ROTARY ENGINE SERVICE BULLETIN

Bulletin No. RE-10
August 22, 1975
Date _____

SUBJECT: RE5 SPARK PLUG INSTALLATION

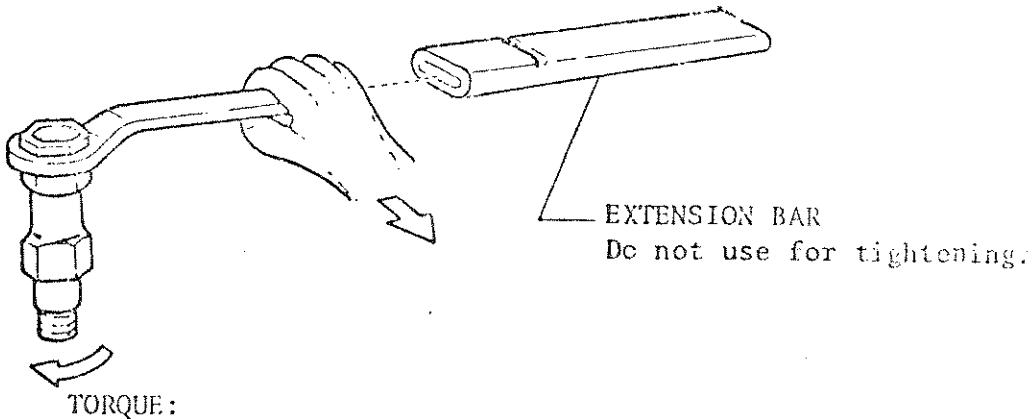
The RE5 spark plug is a taper seat design and does not require a gasket. Taper seat spark plugs require extra care when they are installed, to be sure they are not over tightened.

If the RE5 spark plug should be over tightened in the rotor housing, the copper inserts threads can be damaged or the insert may loosen and separate from the housing. Therefore, it is always recommended to use a torque wrench when tightening the spark plug.

TORQUE TO: 18 ft-lb

Always encourage RE5 owners to use a torque wrench when they install their own spark plugs. If a torque wrench is not available, advise the RE5 owner to use the spark plug wrench supplied in the tool kit without the extension bar. The spark plug can be torque adequately using this method.

SUBJECT: RE5 BAFFLE INSIDE DIAMETER CHANGE

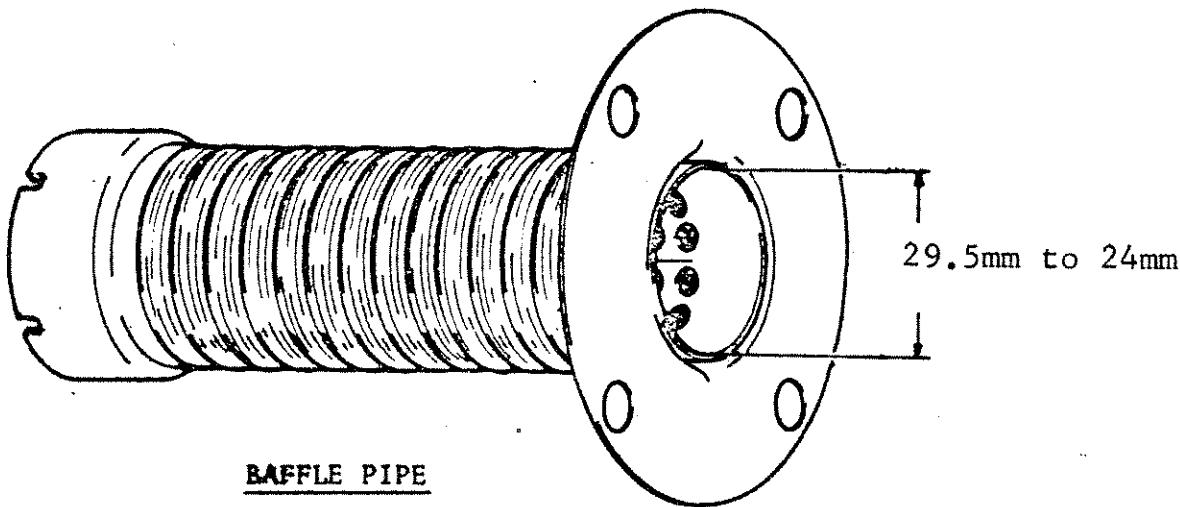
To reduce the RE5's exhaust noise level, the muffler baffles inner diameter has been decreased 5.5mm from 29.5mm to 24mm.

The new style baffles have been installed on and from Frame Number RE5-11901.
